**Government of India  
Ministry of Railways  
Research, Designs & Standards Organisation  
Manak Nagar, Lucknow - 226 011**

**MODIFICATION SHEET NO. RDSO/WAM4/153 (REV.1)**

**PROVISION OF QLA RELAY FOR PROTECTION OF AUXILIARY  
CIRCUIT IN THE EVENT OF PHASE FAULT / OVER CURRENT**

This supersedes modification No. RDSO/WAM4/153 dt. 12.06.1986.

REF.	SCALE	NTS	APPD. BY	-sd- (FOR DG.)
QLA RELAY ARRANGEMENT FOR PROTECTION OF AUXILIARY CIRCUIT				
RDSO ELEC DTE			SKEL-3890 (REV-1)

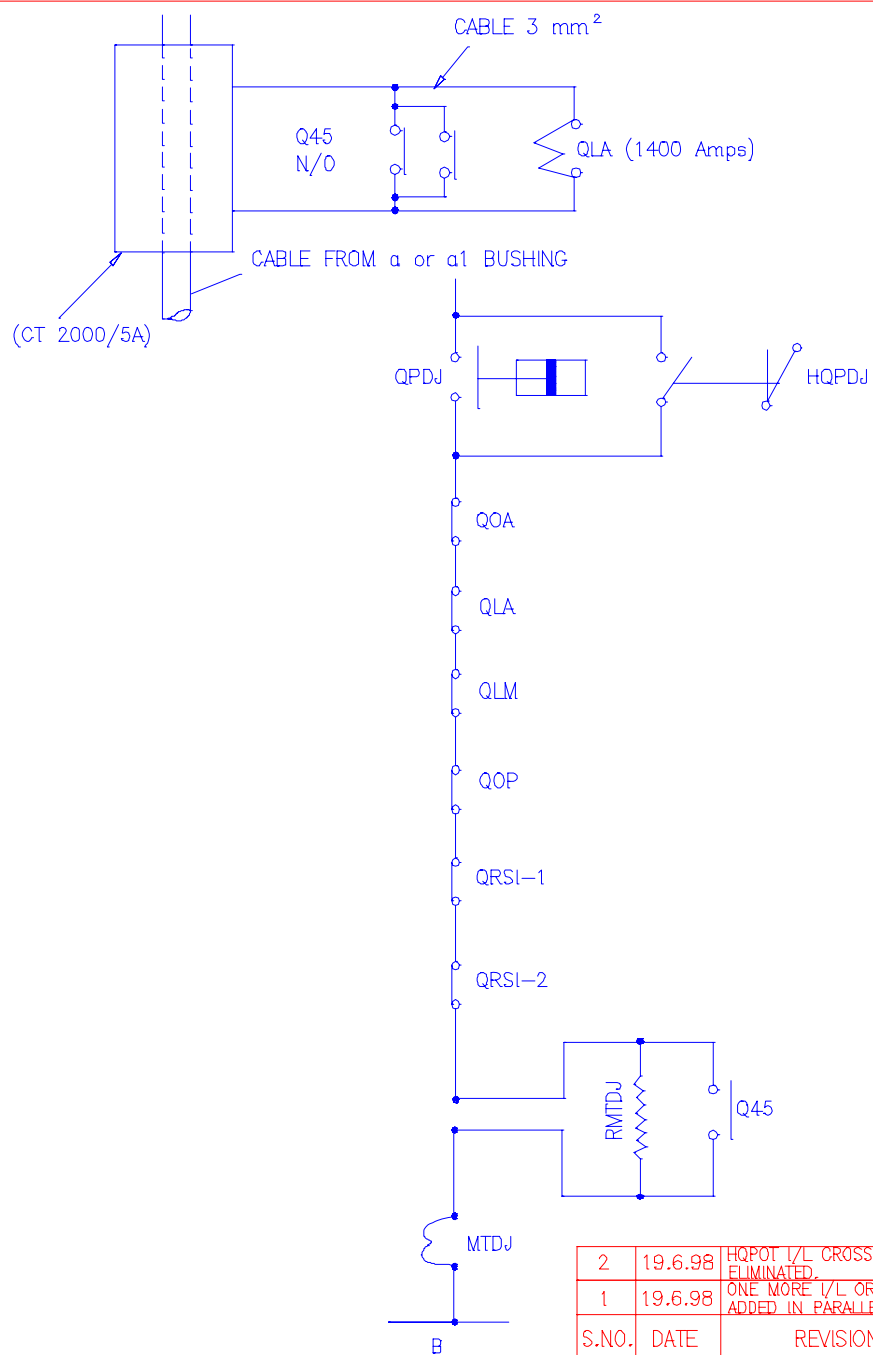
2	19.6.98	HQPDJ I/L CROSS RMTDJ ELIMINATED.
1	19.6.98	ONE MORE I/L OR Q45 ADDED IN PARALLEL
S.NO.	DATE	REVISION

- 2.1 Mount a current trans former (CT) of 2000/5 Amps. ratio at suitable place (capable to withstand intermittent short circuit) on the out going cables of either a0 or a1 bushing.

- 2.2 Mount the DI type QLA relay preferably in the panel where Q45 relay is mounted. Alternatively, this can also be mounted nearest to Q45 relay at a suitable location.

- 2.3 Connect the secondary of CT to the operating coil of QLA relay with 3.0 sq. mm control cable.
- 2.4 Connect 2 Nos. normally open contacts of existing Q45 relay in parallel. In order to avoid tripping at the time of starting of Arno, by pass the QLA relay operating coil through these parallelly connected open contacts of Q45 relay. While making this connection, use thicker cross-section (preferably 10 sq. mm) of control cable to minimise the resistance offered by this path.

- 2.5 Provide N/C contact of QLA relay in the MTDJ circuit. This will ensure tripping of DJ through this contact in case of picking up of QLA relay due to fault in the auxiliary circuit.

- 2.6 Set the QLA relay to trip at 1400 Amps.
